Office Action Summary

10/786,736

SHAFFNER ET AL

DETAILED ACTION

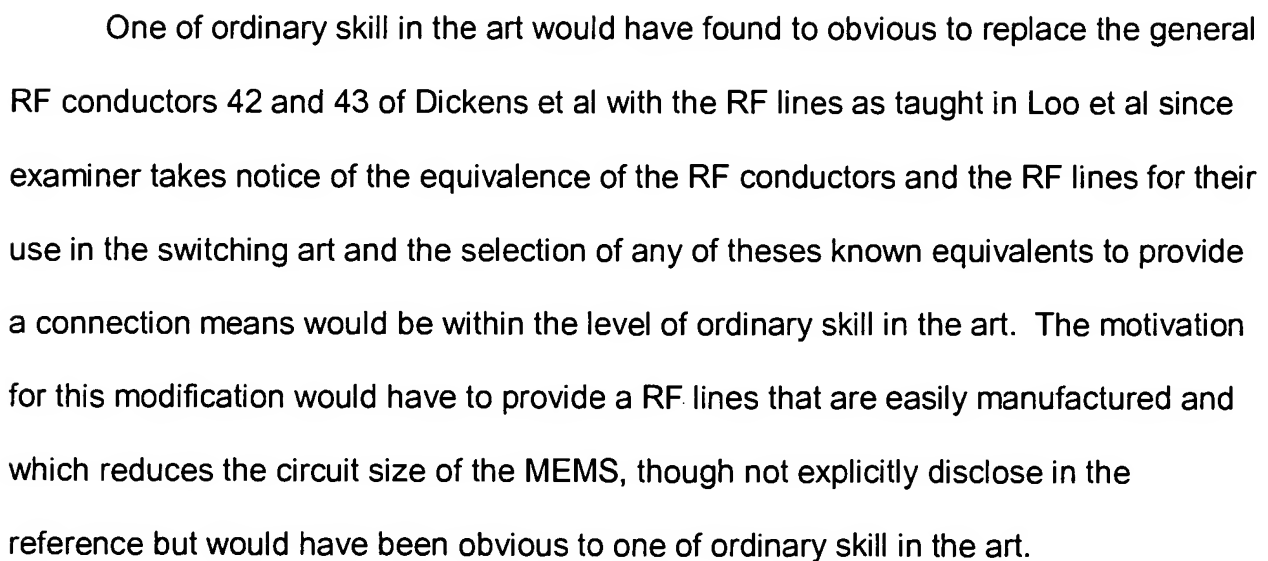
Claims 1, 2, 8, 12 and 13 are rejected under 35 U.S.C. 103(a) as being unpatentable over Dickens et al US Patent 6,657,525 in view of Loo et al US Patent 6,440,767 (both of record).

The primary reference, Dickens discloses in figures 2A through 2C an improved MEMS switch 40 comprising of first and second RF conductors 42 and 43 deposited on a substrate 44. A bridge structure 46 having a central stiffener portion 48 is located above the RF conductors. The central stiffener portion 48 is vertically moveable by virtue of metallic flexible spring arms 50 connected to respective support members 52. The undersurface of bridge structure 48 includes an electrical contact 64, which completes the electrical connection between first and second RF conductors 42 and 43 when the switch 40 is activated. The RF conductor comprises of a tapered section that extends from a narrow portion of the RF conductor to a wide portion of the RF conductors.

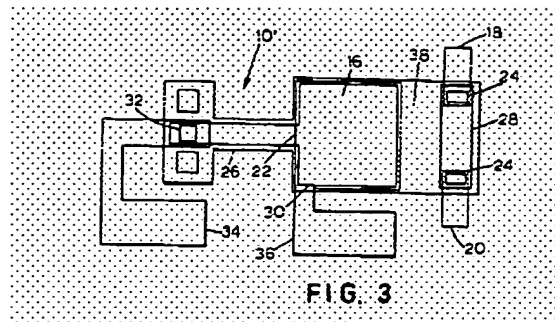
Loo et al '659 discloses in figure 3 a MEM switch 10'. The MEM switch comprises of a conducting transmission line 28, an input line 20, an output line 18, an armature bias electrode 30, an armature bias pad 34, substrate bias pad 36, an armature 16 and a substrate 14. Examiner considers the input line and the output line to be the RF line. With the conducting transmission line represents the RF contact.

The conducting transmission line 28 is located on the underside of the beam structural layer 26 and is not connected directly to either the input line 20 or the output line 18. The armature bias electrode 30 covers the majority of the underside of the armature 16 and the beam structural layer 26. One end of the armature 16 is affixed directly to the substrate 14. The free end of the armature 16 rests over both the input line 20 and the output line 18. The conducting transmission line 28 is located on the free end of the armature 16, also above both the input line 20 and the output line 18. When a voltage is applied between the substrate bias electrode 22 and the armature bias electrode 30, the armature 16 will bend towards the substrate 14. This forces the conducting line 28 into electrical contact with both the input line 20 and the output line 18. Signals can then pass from the input line 20 to the output line 18 through the conducting transmission line 28. A positive or negative voltage is place on either the armature bias pad 34 or substrate bias pad 36 and a ground signal is placed on the other. Therefore, whichever pad receives the ground signal is considered the ground plane.

Thus Loo et al '659 is shown to teach all the limitation of the claims with the exception of the RF line having only one protuberance or hump adjacent to at least one RF contact.

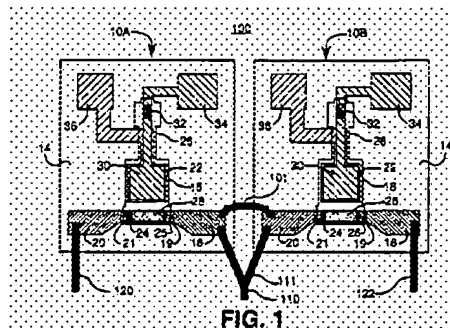
Loo et al '767 discloses in figure 1, a MEMS switch wherein the RF lines 18 and 20 having only one protuberance or hump. Examiner considers the taper section RF lines 18 and 20 to be the protuberance or hump.

One of ordinary skill in the art would have found to obvious to replace the general input/output line 18 and 20 of Loo et al '659 with the RF lines as taught in Loo et al '767 since examiner takes notice of the equivalence of the input/output lines and the RF lines for their use in the switching art and the selection of any of these known equivalents to provide a connection means would be within the level of ordinary skill in the art. The motivation for this modification would have to provide a RF lines that are easily
